Proposal is based on GRRF-85-02-Rev.

Proposals for Category C2 with Blind Spot Sensors

Proposal for the 03 series of amendments to UN Regulation No. 79

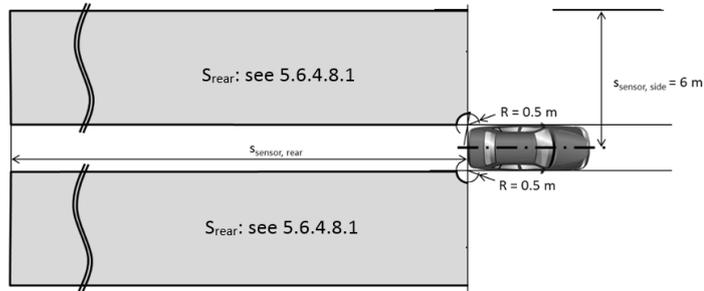
5.6.4.8.1.2. The vehicle system detection area on ground level shall be at minimum as shown in the figure below.

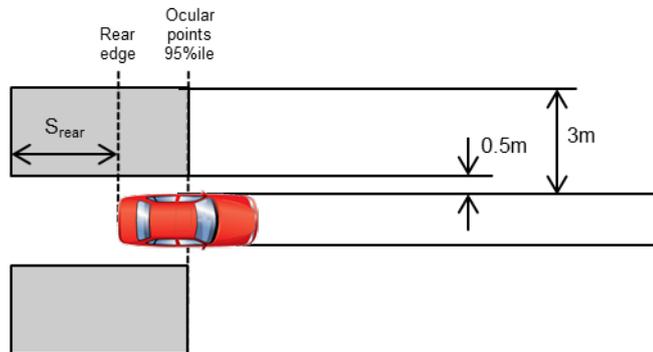
5.6.4.8.2 Minimum distance for systems requiring a separate (second) deliberate action to initiate the LCM (see. Par. 5.6.4.6.4)

5.6.4.8.2.1. The ACSF of Category C shall be able to detect vehicles approaching from the rear in an adjacent lane up to a distance S_{Rear} of 3m behind the vehicle.

5.6.4.8.2.2. The vehicle system detection area on ground level shall be at minimum as shown in the figure below.
